Addendum No.: 4

Date of Addendum: June 17, 2020

Willard Diloreto Parking Garage
Paul Manafort Sr. Drive
New Britain, CT
CF – RC – 402

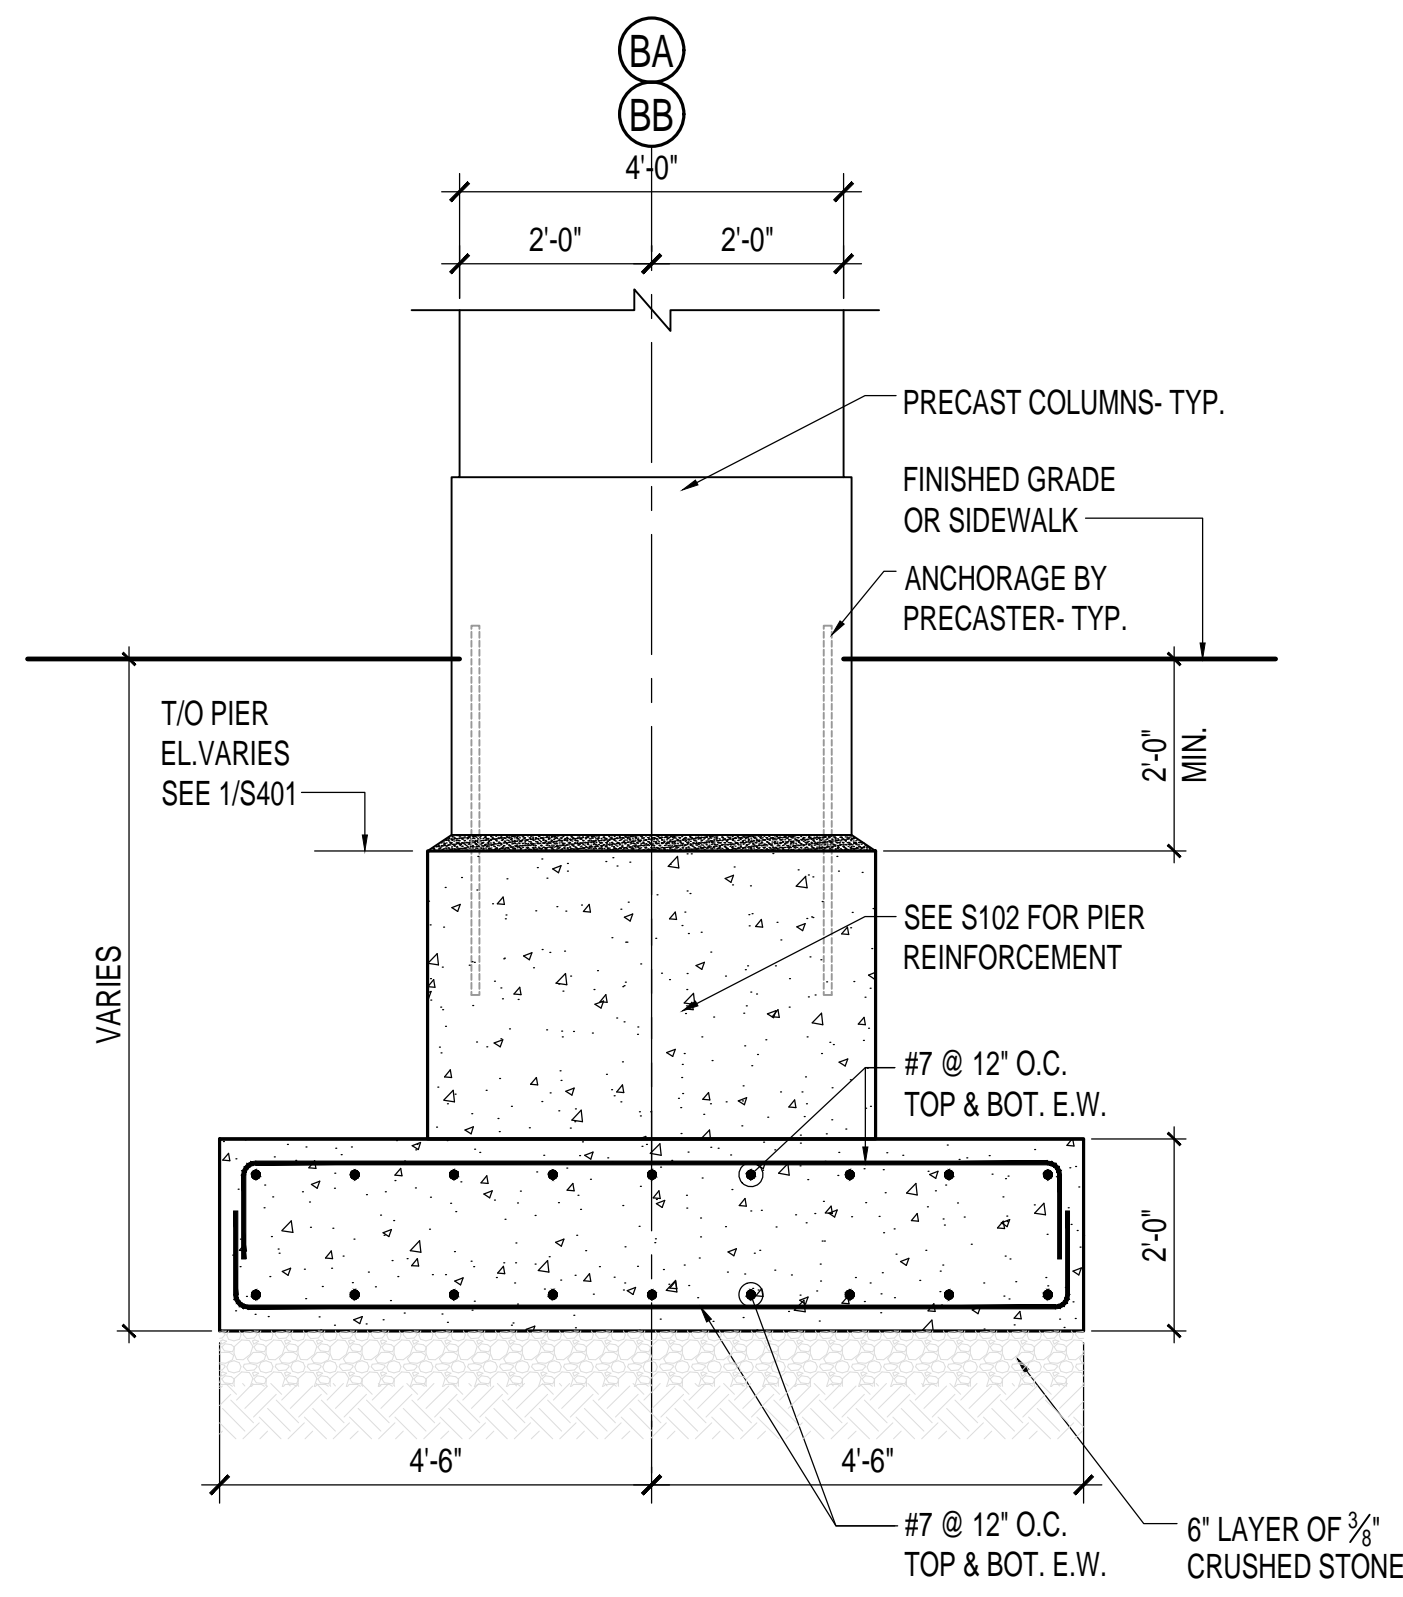
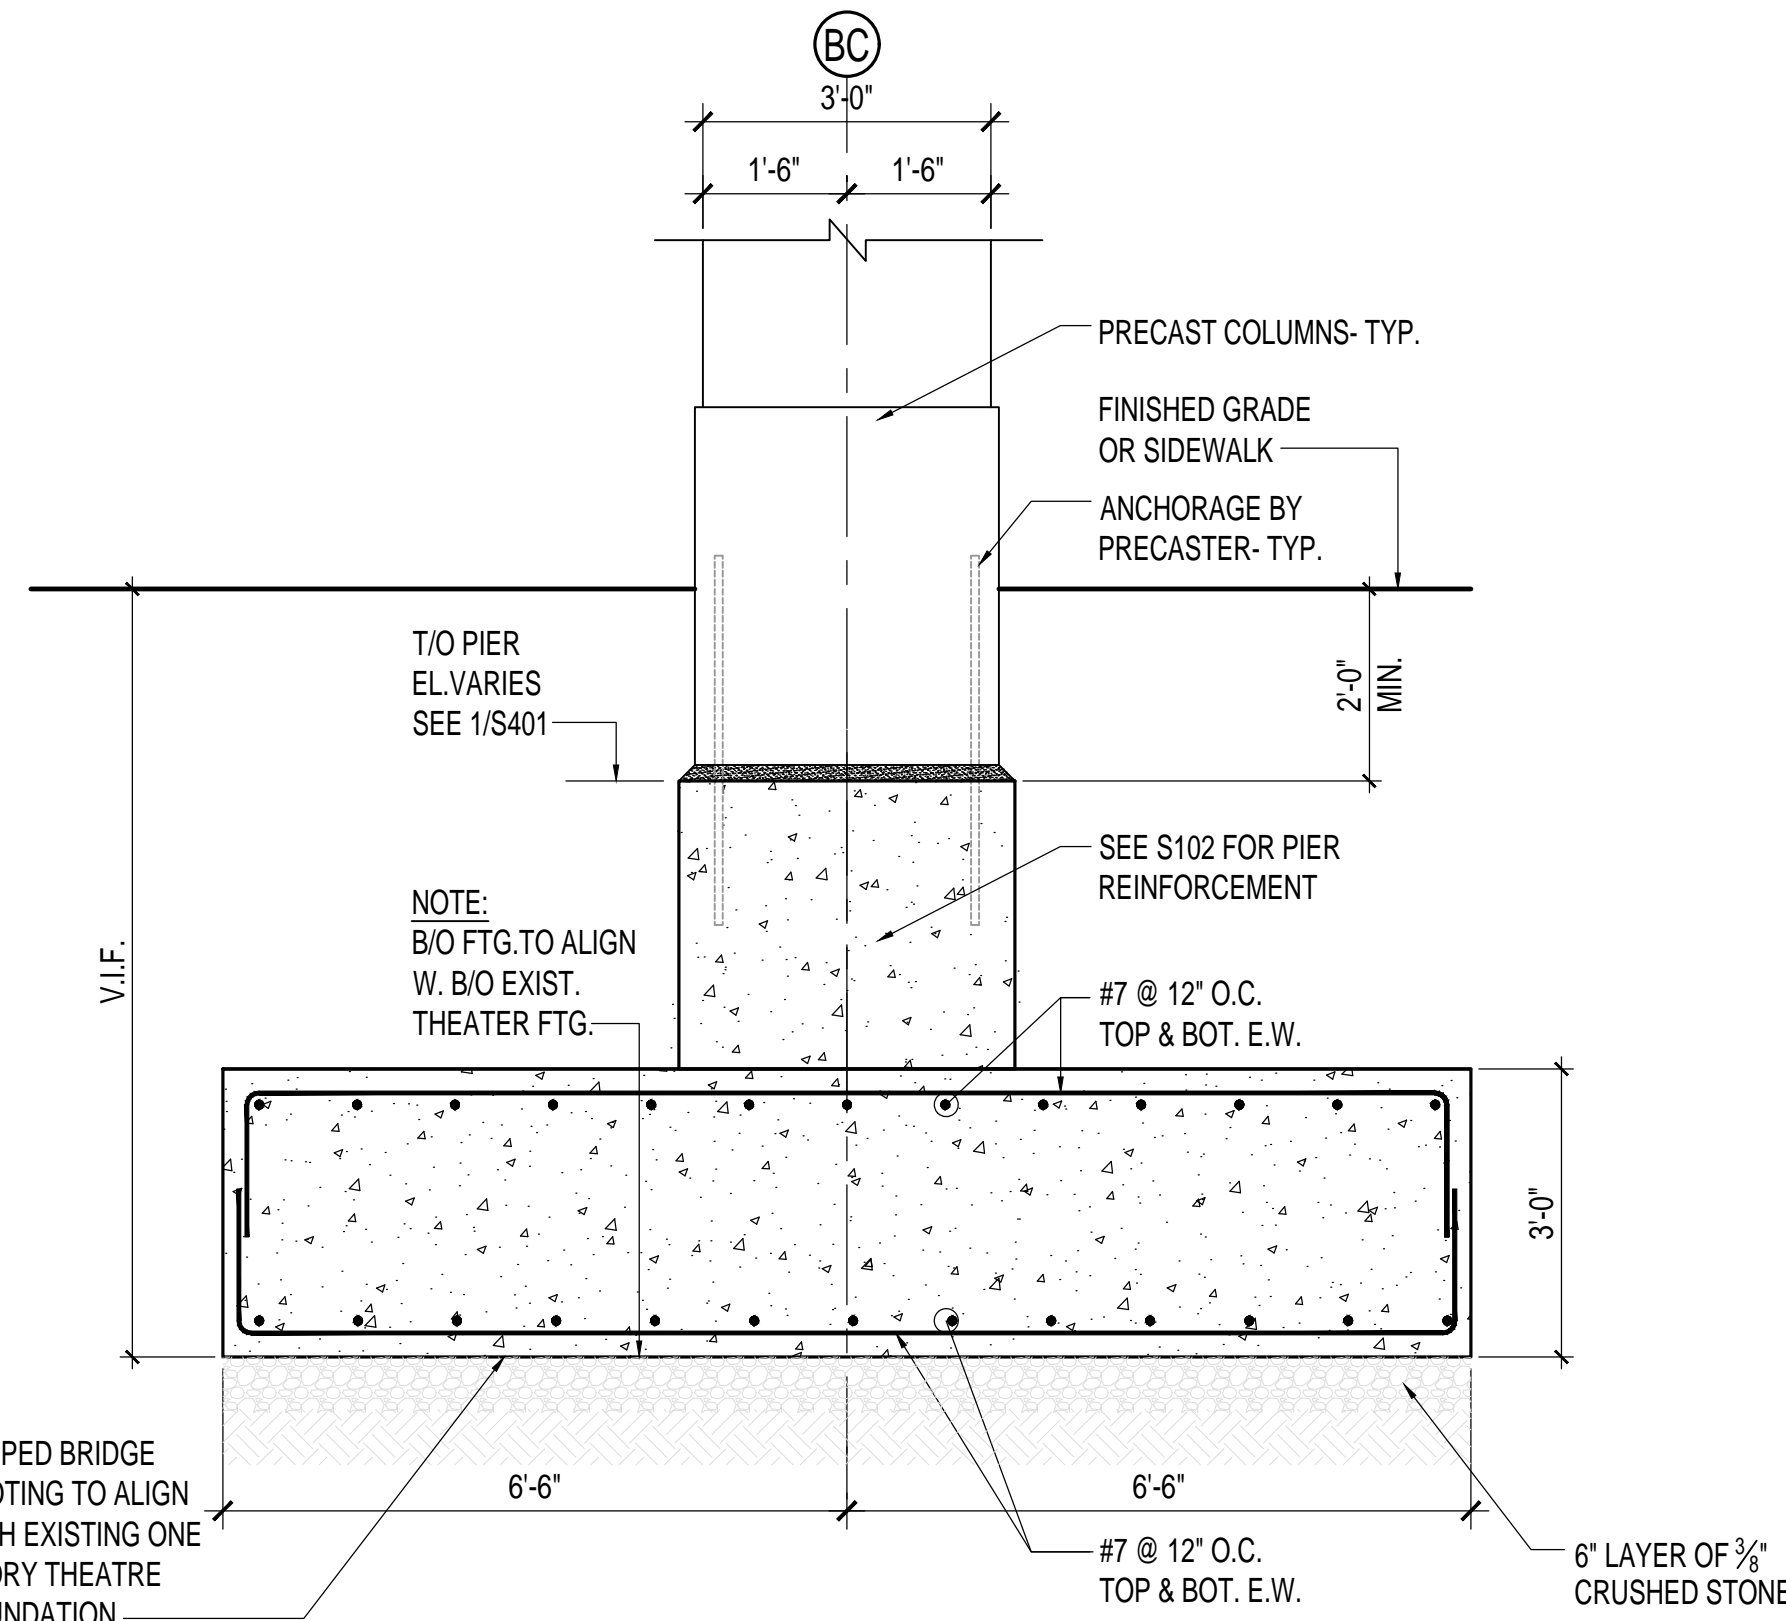
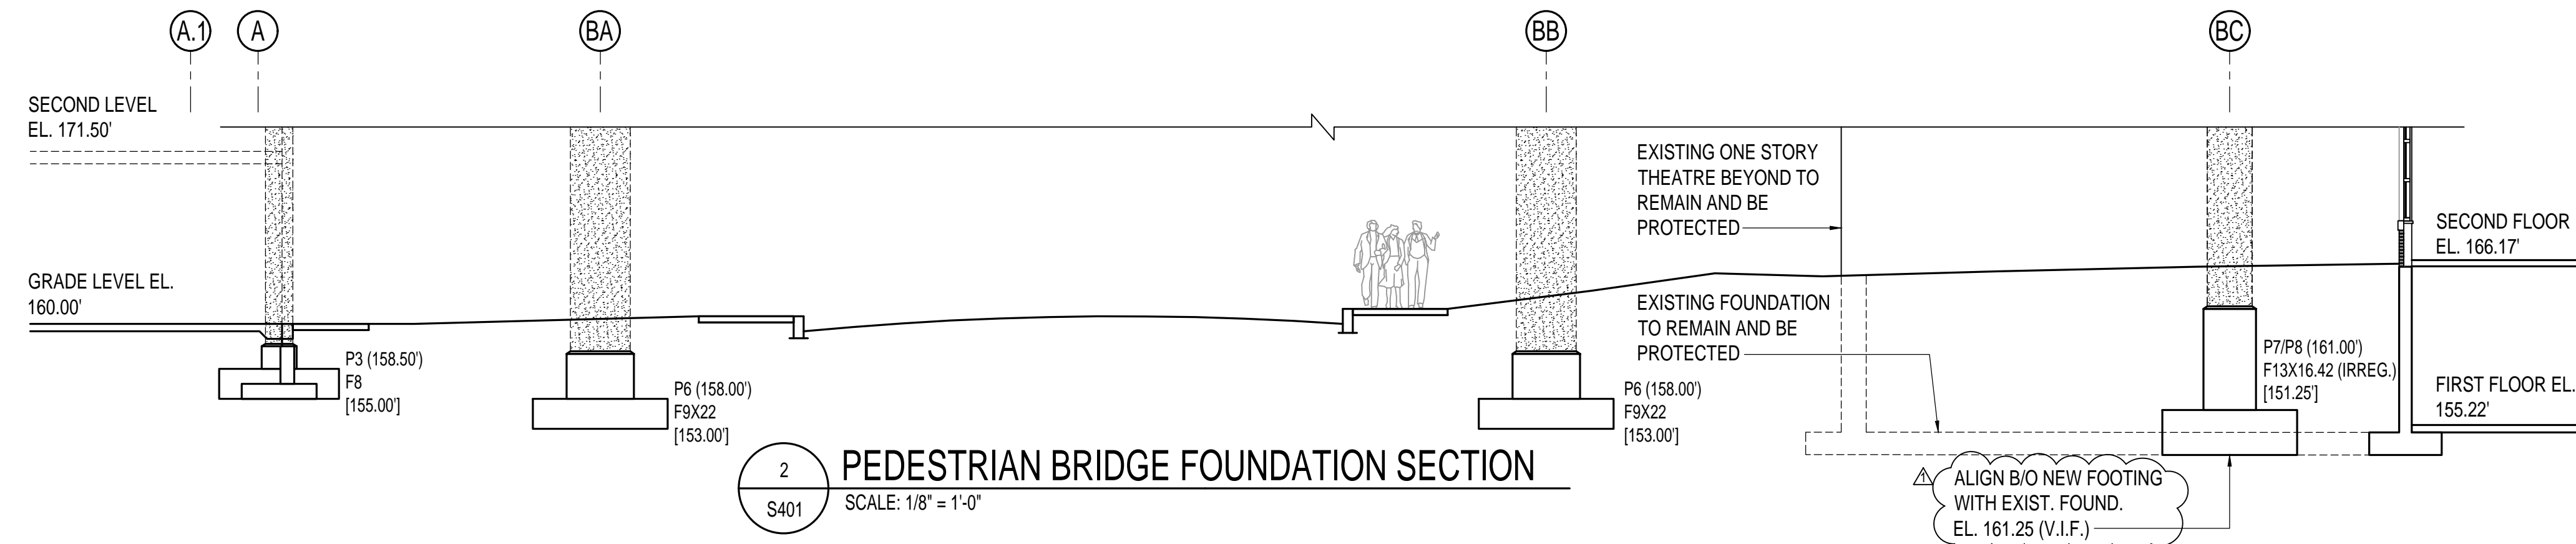
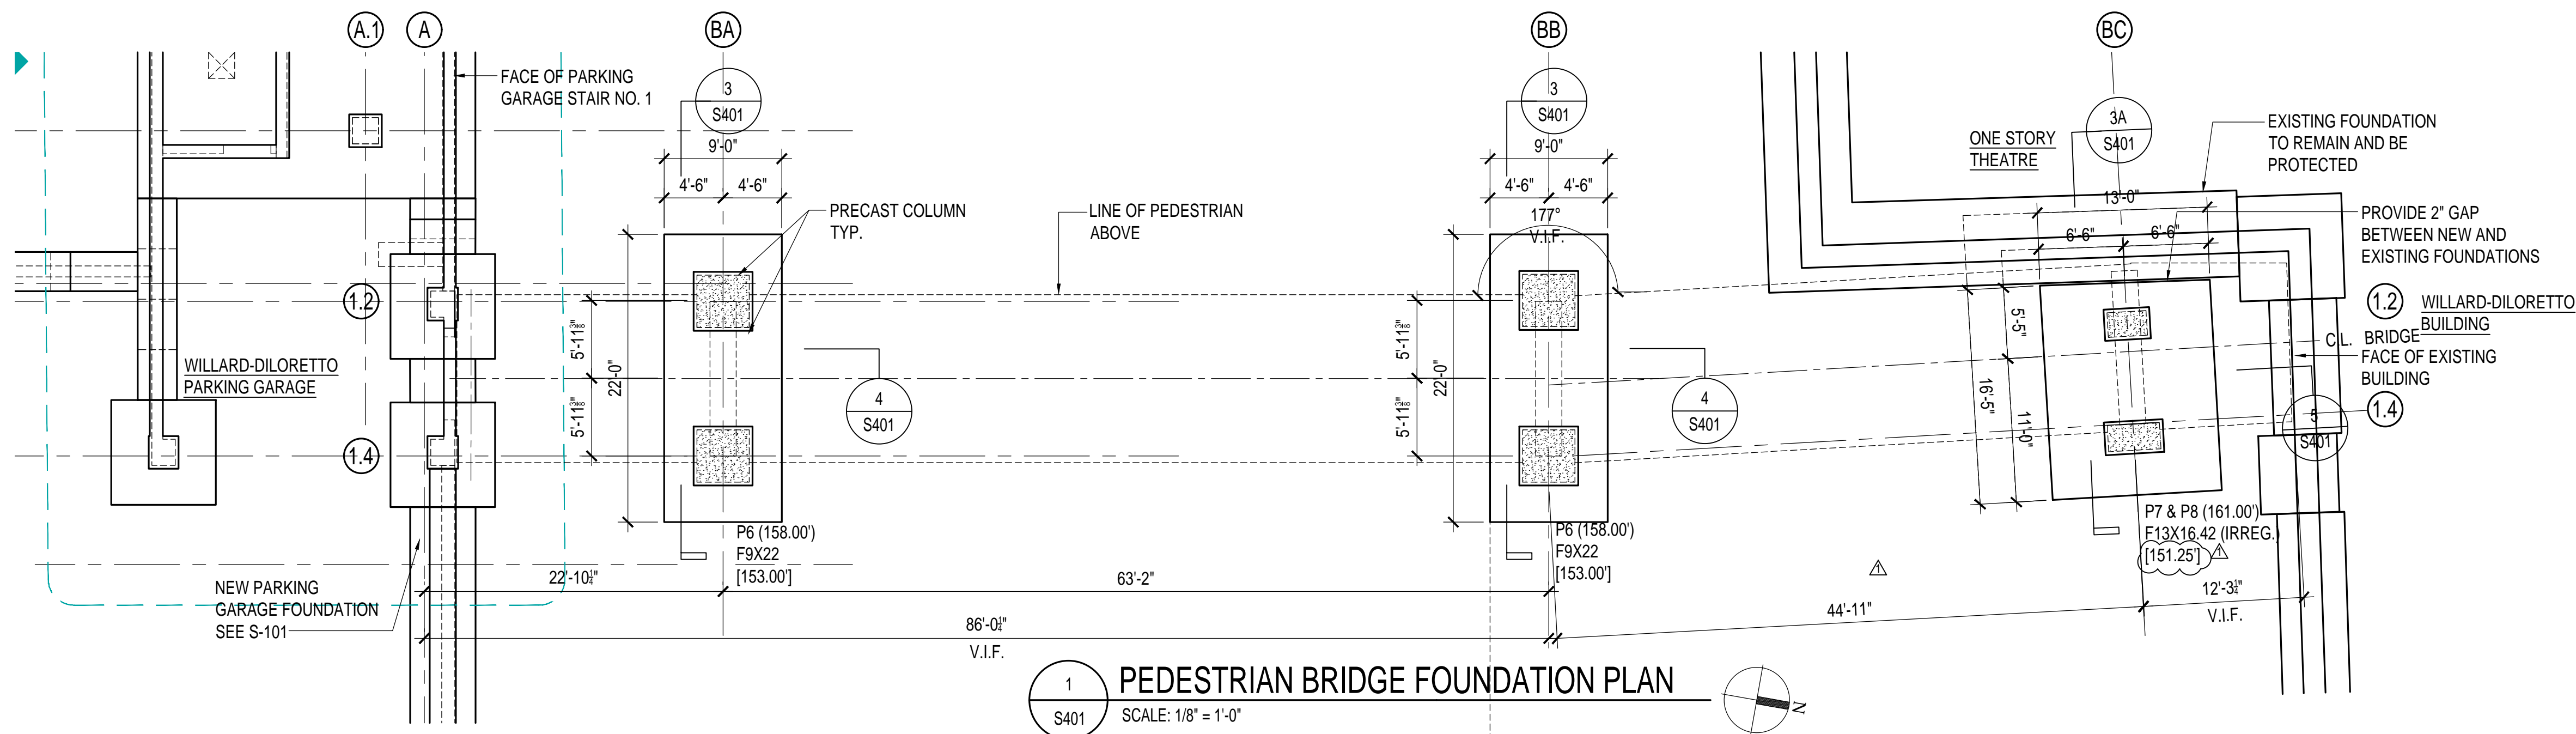
Question: Dwg S401. Details 1, 2 & 3A. Please provide expected elevation of bottom of footing of existing building in vicinity of footing on grid line BC. Please provide coordinated bottom of footing elevation for new footing as there are conflicting bottom of footing elevations indicated by each of the details.

Answer: See revised drawing S401 with bottom of existing and proposed footing elevations indicated.
